Re: Sediment Overflow Pond As-Built Amendment Deficiencies, Sufco Mine, Permit Number C/041/0002,
Task ID#4393

Please find enclosed with this letter an amendment to the Sufco Mine Permit to address the as-built for the overflow pond at Sufco. We have included one redline/strikeout copy of the text and of the maps associated with this amendment.

CHAPTER 2

Sufco - Overflow Sediment Pond
Topsoil Stockpile Quantity Exhibit

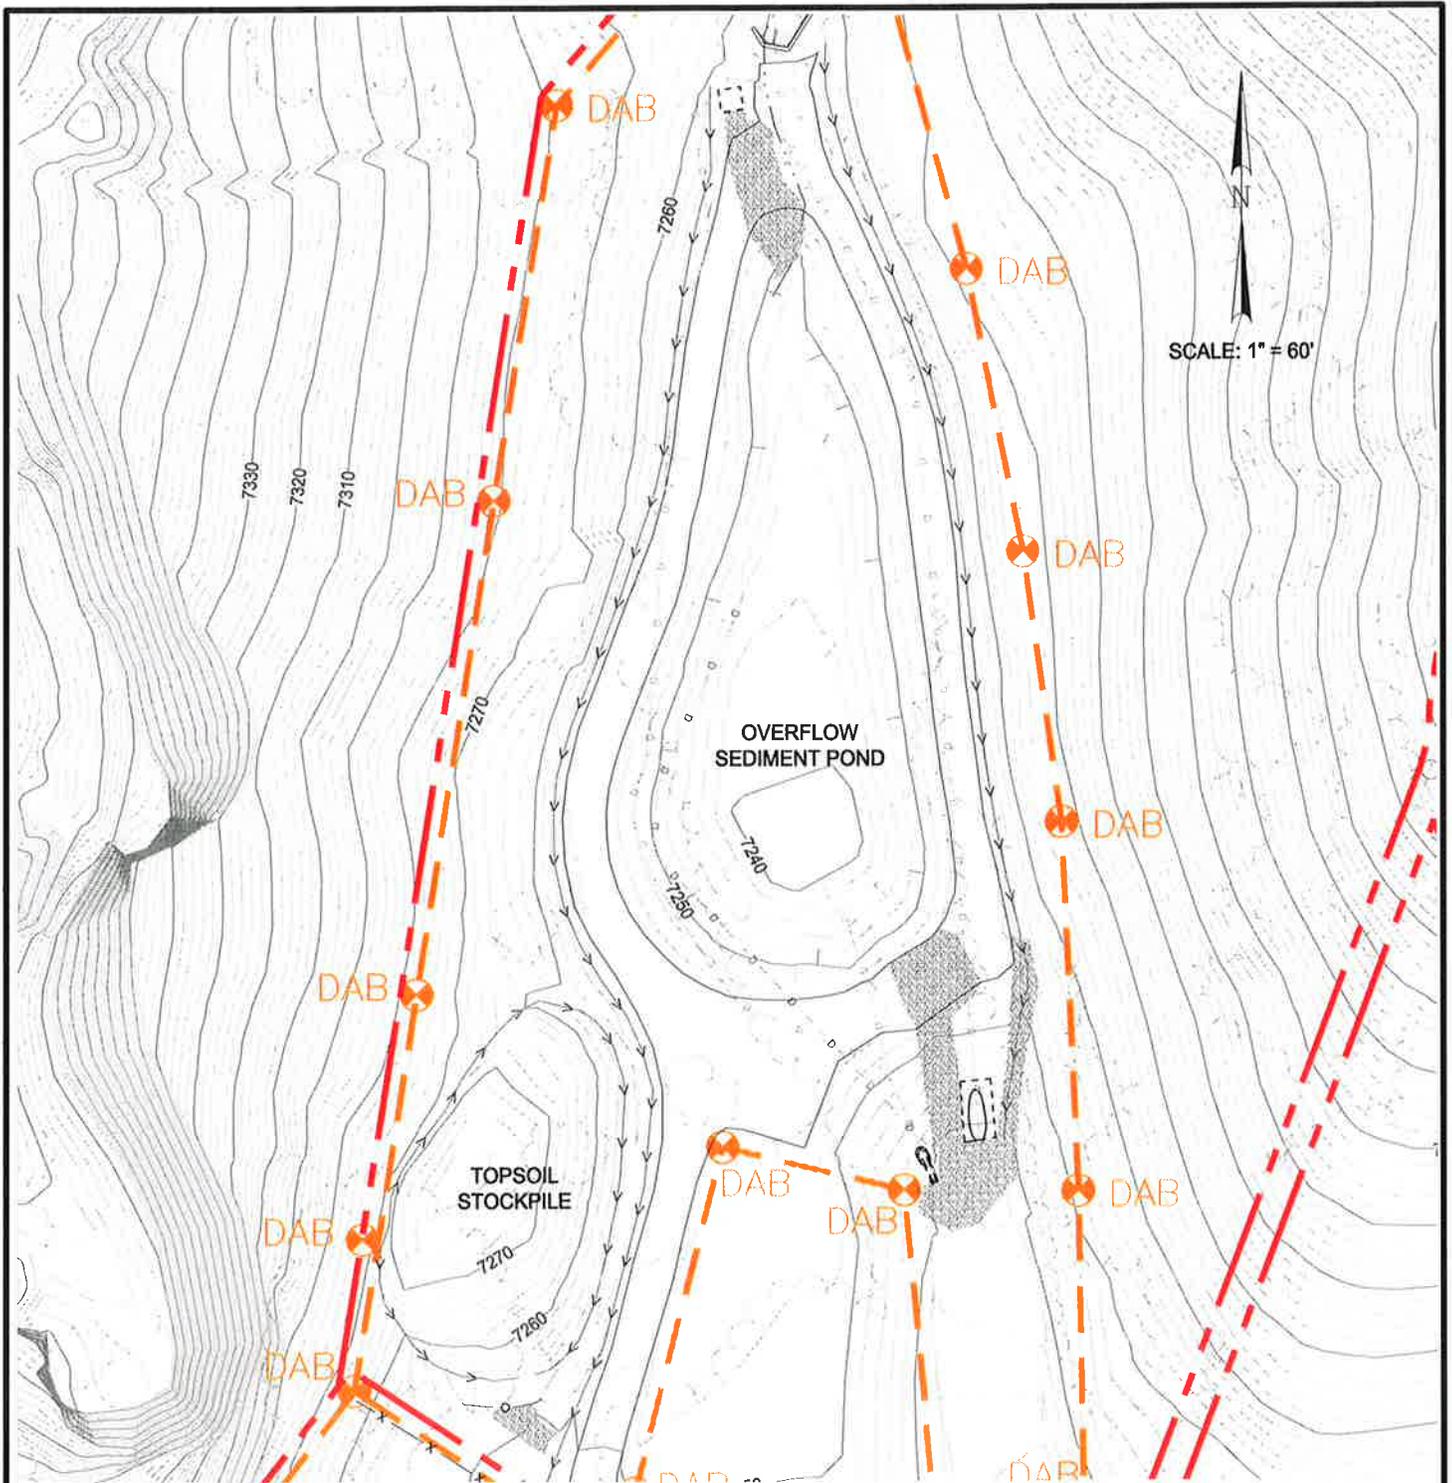
An Order1 soil survey of the overflow pond soils completed by Robert Long is included in Appendix 2-2 as requested, as is a revised exhibit of the topsoil pile stored from the construction of the overflow sediment pond. The narrative of Section 2.2.4 was revised to be more clear, there areas which have the potential to provide growth medium/substitute topsoil for final reclamation, but the applicant cannot state accurate quantity or suitability of these soils. If you have questions or need addition information please contact Vicky Miller at (435)286-4481.

A site specific soil survey will be completed for the Overflow Pond prior to disturbance and this information will be utilized in determining topsoil salvage depth. During topsoil removal observations and measurements in the field will be conducted by the site construction supervisor or a trained representative. **Actual volume of topsoil removed and stockpiled for the Overflow Pond was 1,488 cubic yards.**

Site	Stratum	Surf1	Surf2	Unadjusted Cut yards	Fill yards	Net yards	Method
TOPSOIL	topsoil	topsoil-base	topsoil-pile	0	1486 Cu. Yds.	1486 (F)	Grid
				0	1488 Cu. Yds.	1488 (F)	Composite
				0	1488 Cu. Yds.	1488 (F)	End area
